Subject: Data Response, Set 2A-2
Hidden Hills Solar Electric Generating System (11-AFC-2)

Hidden Hills Solar Electric Generating System

(11-AFC-2)

**Data Response, Set 2A-2
(Response to Data Request 141)**

FIGURE 1. APT WELL LOCATIONS AND DRAWDOWN IN FEET AT DAY 1 AND DAY 4.

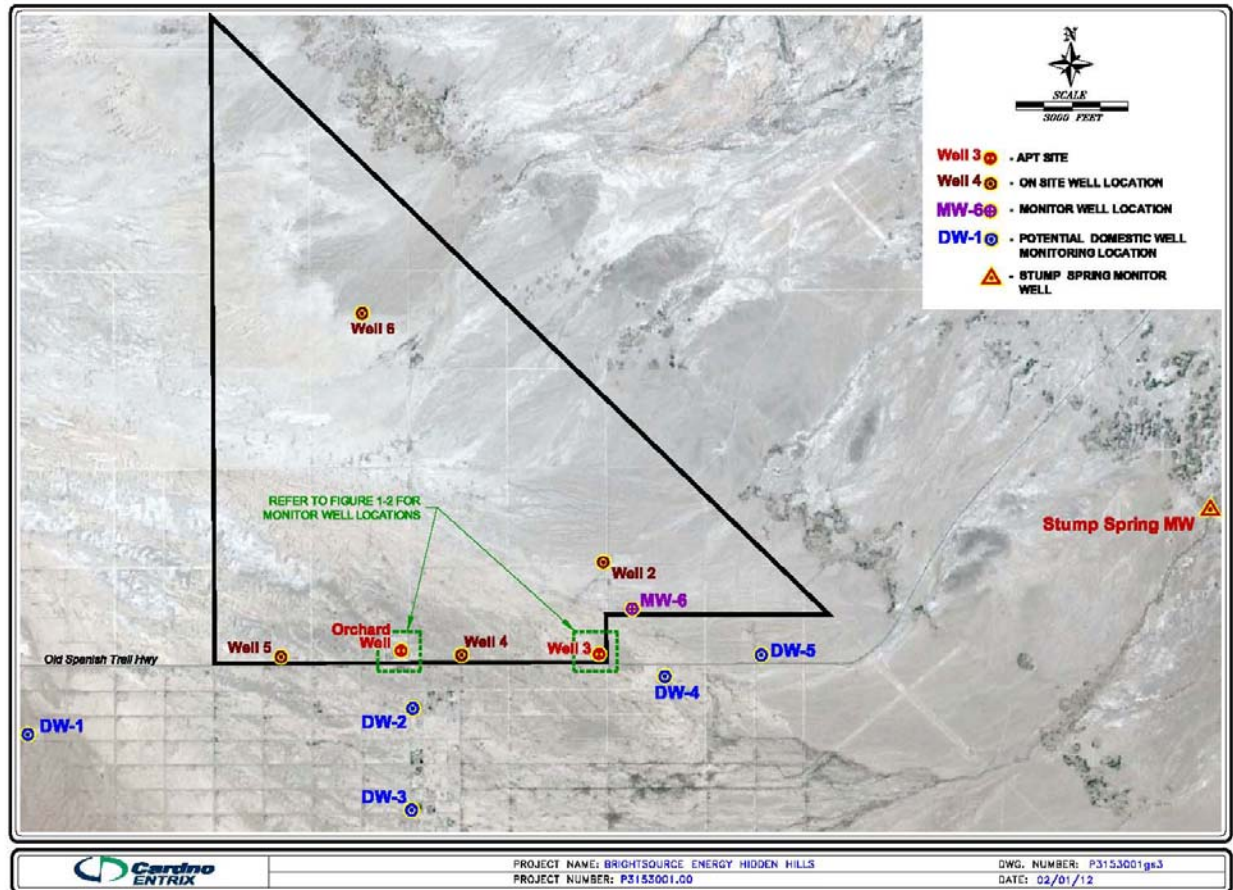
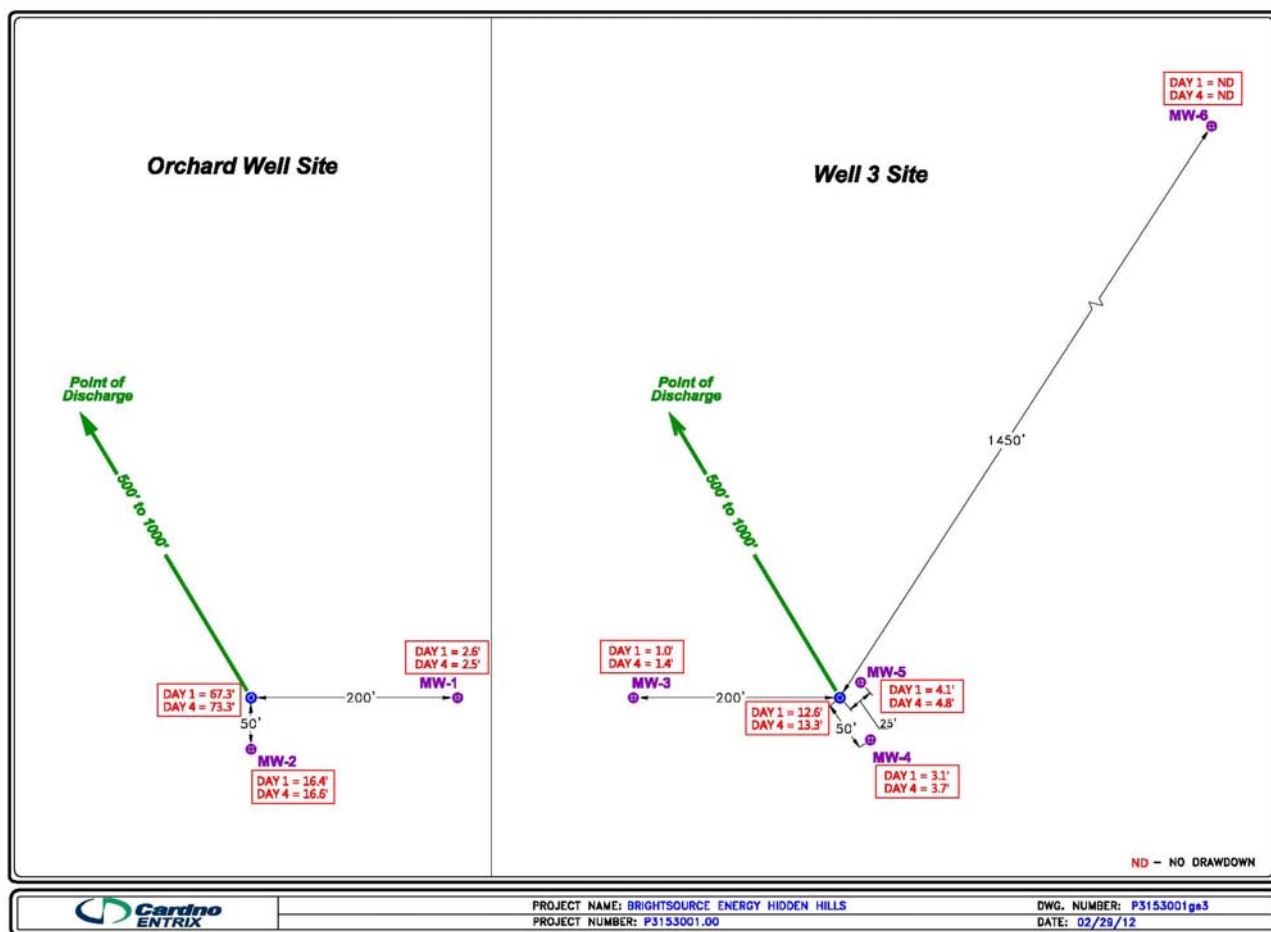
141. Please provide the results of a pump test of sufficient duration and flow to demonstrate that the aquifer can provide a reliable supply for project construction and operation. The pump test should also provide sufficient data to evaluate whether any barriers to flow exist.

As an initial effort to select the wells to use for the APT, an evaluation of the six existing production wells located on the site was conducted (Figure 1). The following results were determined from this effort:

- Two of these existing wells appeared viable for the test -- the Orchard well and Well #3
- Two of these existing wells (Well #2 and Well #4) were not sufficiently deep to support pumping withdrawals for the purposes of the APT, but were useful as water level monitoring
- Two of these wells (Well #5 and Well #6) were dry and no standing water was present in them

Temporary pumps were installed in both the Orchard well and Well #3 for the duration of the APT. A series of six 200-foot-deep monitoring wells were installed at strategic locations near each of these wells (Figure 1). Data recording pressure transducers were installed in each of the monitoring and pumping wells to document water level changes before, during, and after the APT. Additionally, water level changes were tracked at the existing monitoring well located at the Stump Springs area (illustrated as eastern edge of the map provided as Figure 1). The data from these devices were downloaded and used to generate graphs and other analyses of the observed water level changes during the test.

The water level changes observed during the course of the test are illustrated in Figure 2. At the Orchard well, observed water level drawdown was a total of approximately 73 feet during the course of the test (Figure 3), while the drawdown at the monitoring wells located 50 and 200 feet away from the Orchard well were 16.6 and 2.5 feet, respectively. Measurable drawdown was not evident in the existing wells (Well #2 and Well #4). Water levels in the Stump Springs monitoring well followed a declining trend from about a month before the start of pumping and continued the same trend without significant change during and after the pumping test.
